SUBJECT: NuScale Power, LLC Response to NRC Request for Additional Information No. 136 (eRAI No. 8933) on the NuScale Design Certification Application

eRAI No.: 8933

NRC Question No.: 03.07.02-17

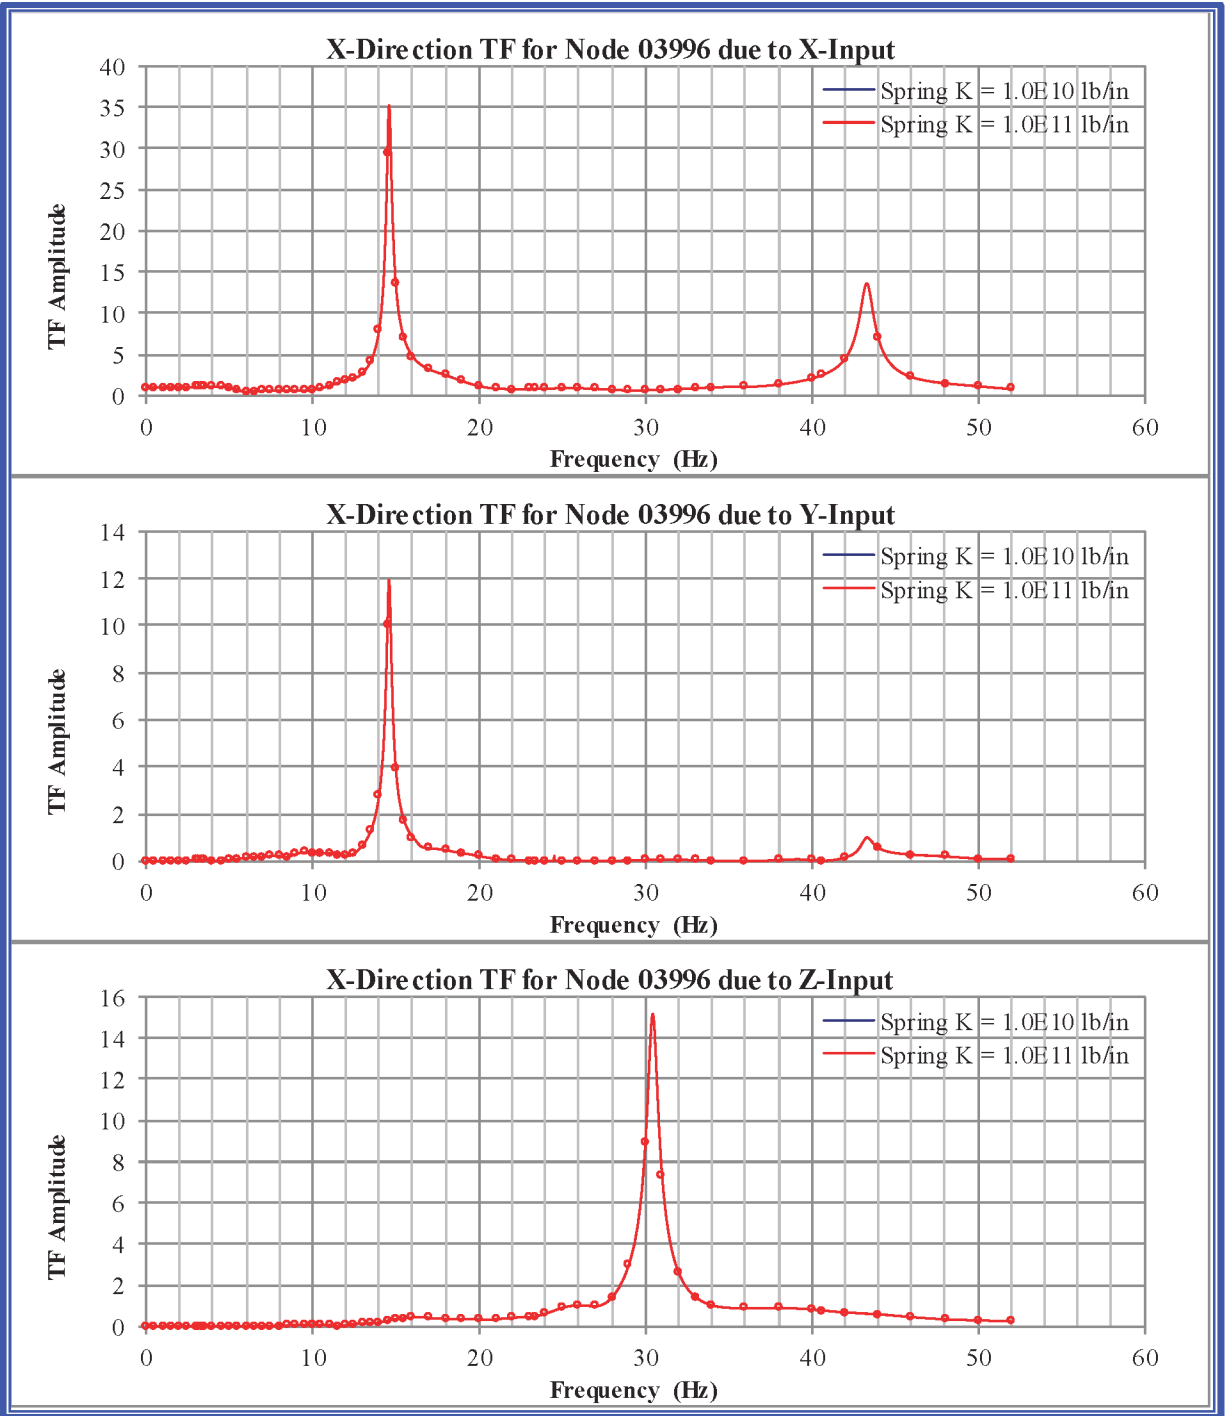
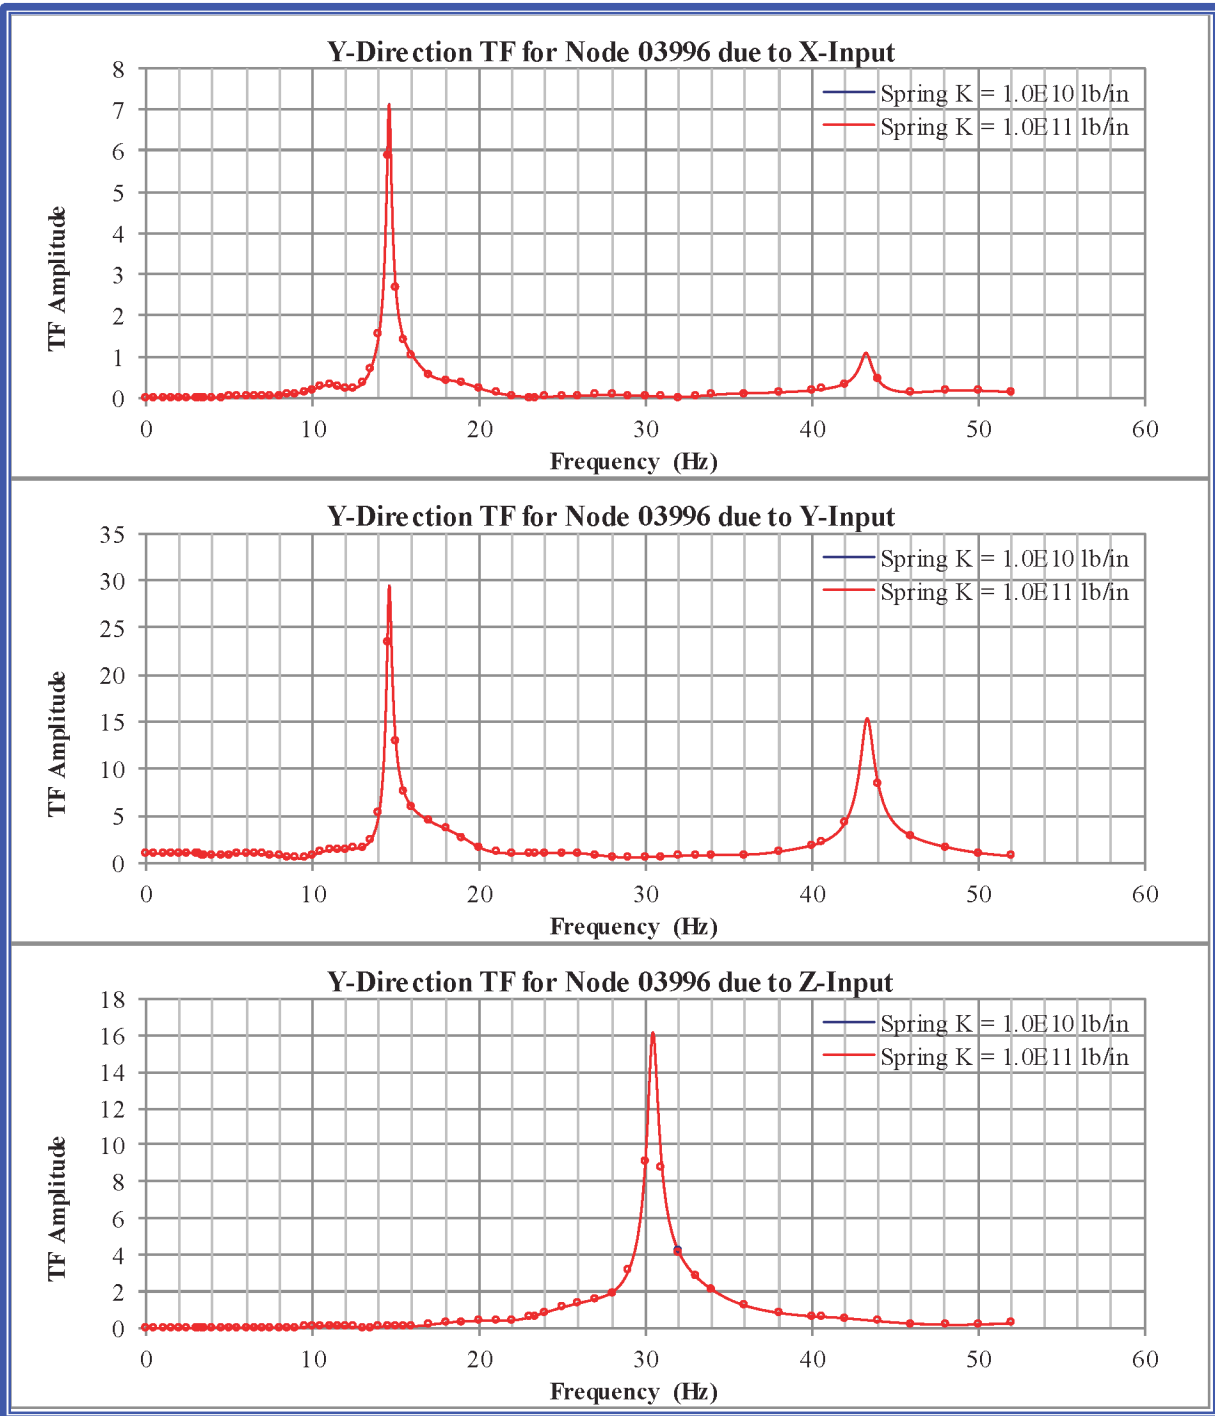
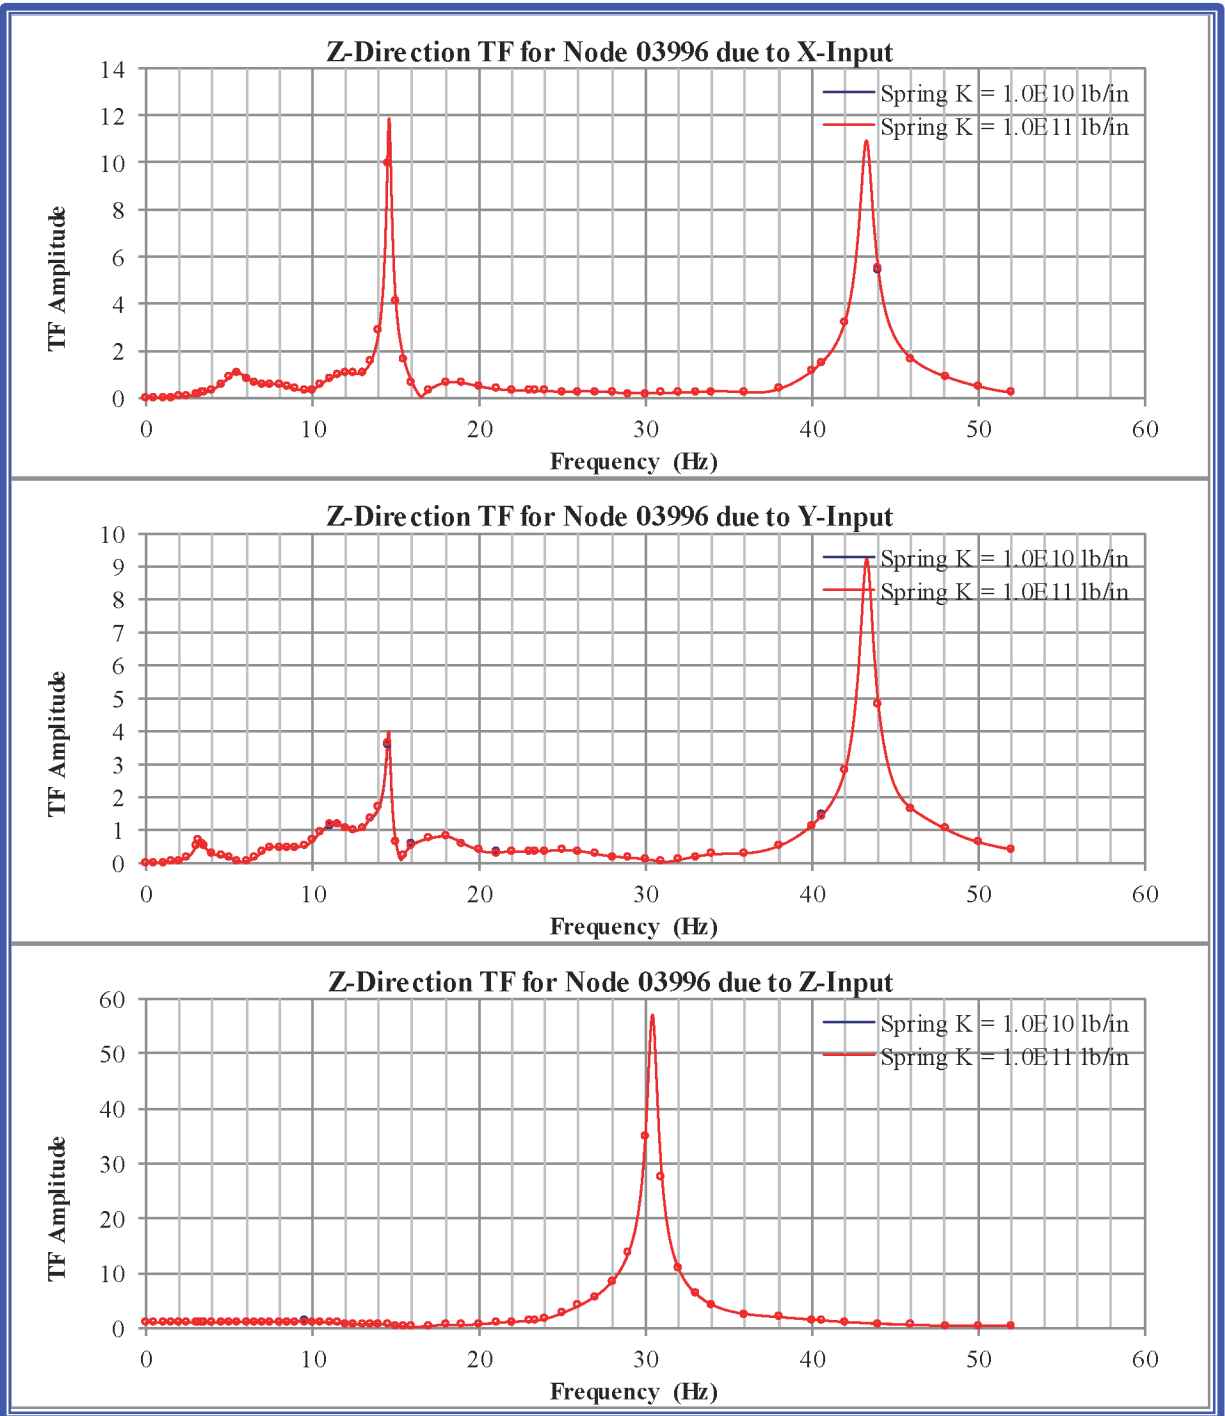
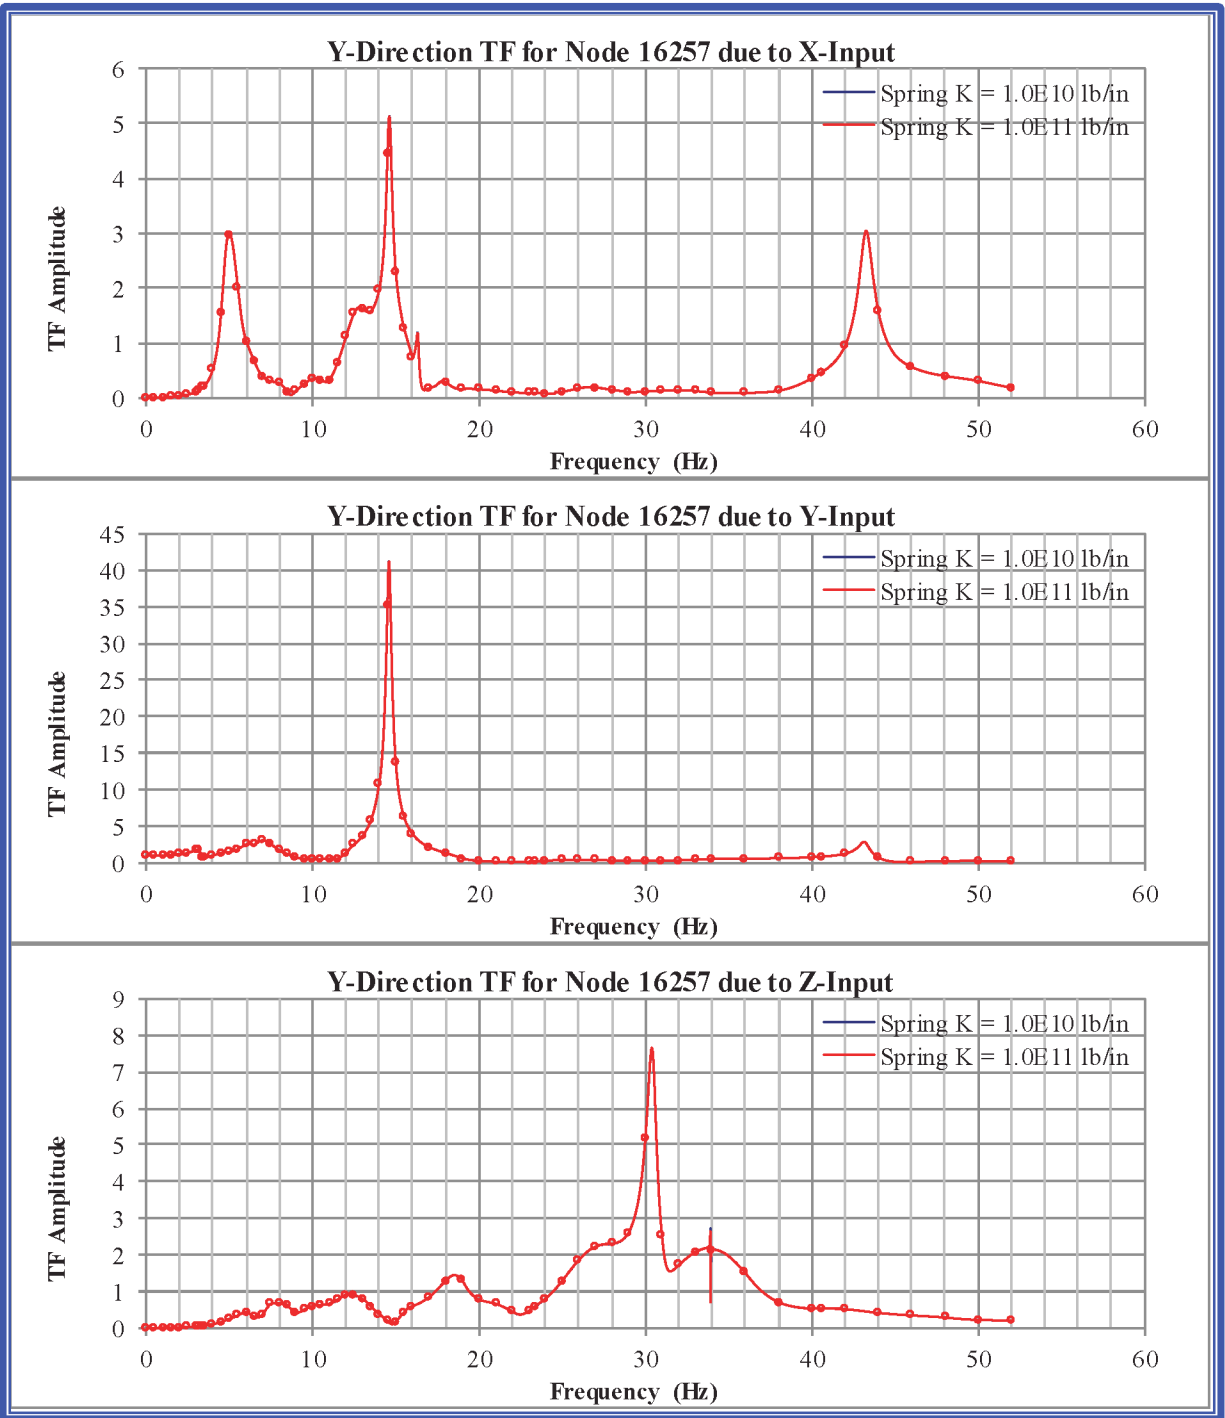
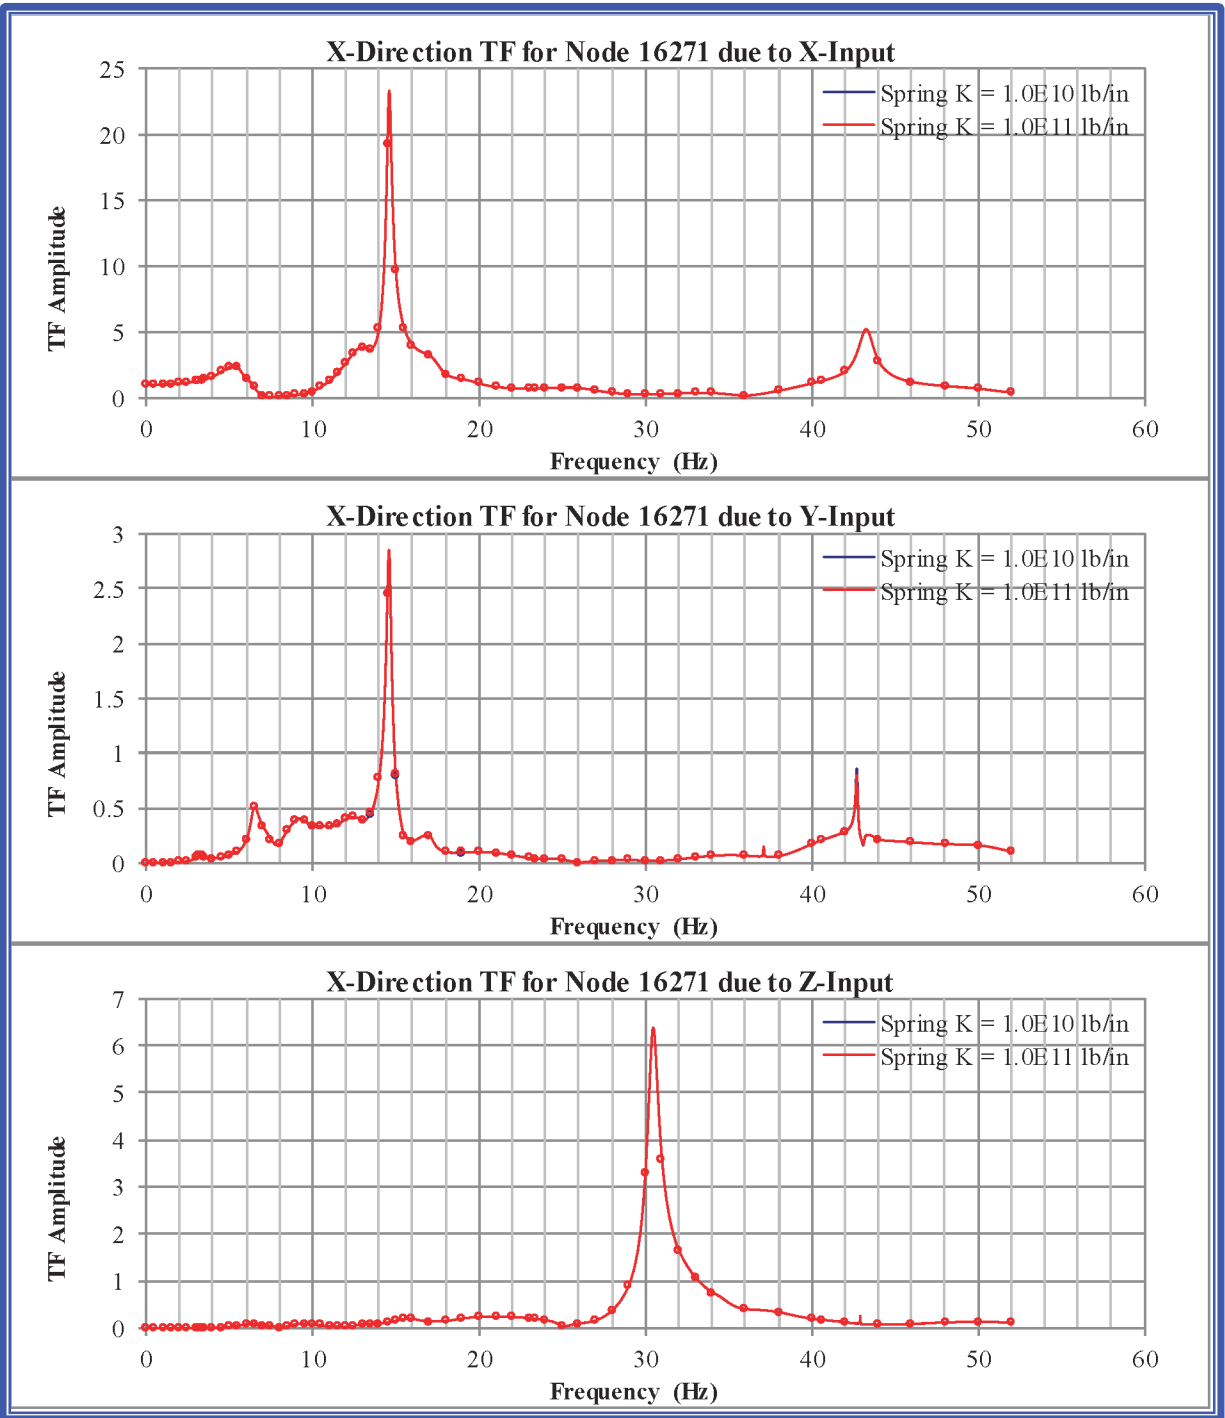
- b. On Page 3.7-25 of the FSAR, in the sixth paragraph, the applicant states, “The rigid springs have a zero length and have a stiffness value large enough to simulate rigid connection. The large stiffness used is arbitrarily chosen to be ten billion lbs per inch, or 1010 lbs/inch, in the three global directions.” For the spring to be modeled as a rigid spring, the value of its spring constant should be sufficiently larger than the stiffness of the structural element (basemat) to which it is attached. The applicant is requested to confirm the adequacy of the number (1010 lbs/inch) chosen for the spring constant by comparing it to the stiffness of the adjacent basemat element or through an appropriate sensitivity run using a number at least an order of magnitude different.

The locations of the nodes are shown in Figure 1-1 through Figure 1-4. The cracked concrete model with 7% concrete damping was used to generate these results. The TF comparisons are shown in Figure 1-5 through Figure 1-19. There are no discernible differences in the transfer functions between spring $K = 10^{10}$ lb/in and spring $K = 10^{11}$ lb/in.
